Concern
Characterization objectives: Determine the extent of LNAPL and dissolved phase benzene, and monitor the dissolved phase plume to determine if it is migrating downgradient

Overview Slide (#3)

Transition to EBR Criteria

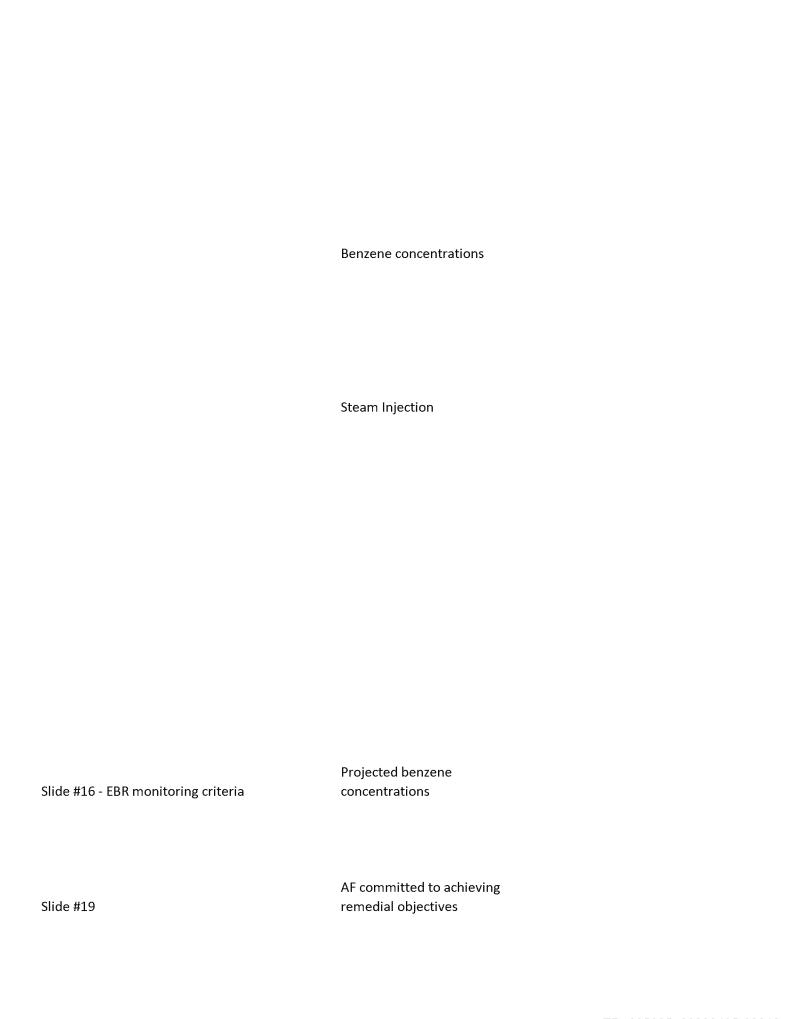
EPA agrees that this criteria was met

The Target Criteria for Mass Removal given in Table 4-2 of the Final RD/RAWP is given as, "Less than 10 percent of peak removal rate." EPA response to this before it was finalized was that the peak removal rate could be very high, such that 10% of the peak removal rate is still a very high extraction rate, and we would expect that removal rate would be low before SEE was terminated. Peak rate was greater than 12,000 lbs/day, and removal rate when SEE was terminated were in the range 9 - 27% (April 20, 2016 slides, #16). The trend in vapor phase removal at that time was increasing.

Mass removal rates currently from the SVE system after dismantling of SEE are still greater than the 10% of peak criterion considering vapor alone. The SEE system was effectively removing LNAPL at the time it was shut down

Not clear where the criteria for benzene concentrations < 5,500 ug/L suitable for transition to EBR came from, This was not part of criteria for transitioning from SEE to EBR. According to the benzene concentration estimates available at the time SEE was terminated, even this very lenient criteria was not met in UWBZ and CZ. The benzene concentration criteria in the RD/RAWP was 100 -500 ug/l, according to the data provided on July 15, this is not met in wells CZ18 or LSZ37.

As a guideline for SEE termination, we would expect actual steam injection usage to be less than the design only if all the other data indicated clearly that the termination criteria had been met. SEE was terminated without meeting SEE was terminated at 94% of original projection; the mass removal or benzene concentration or steam injection criteria.
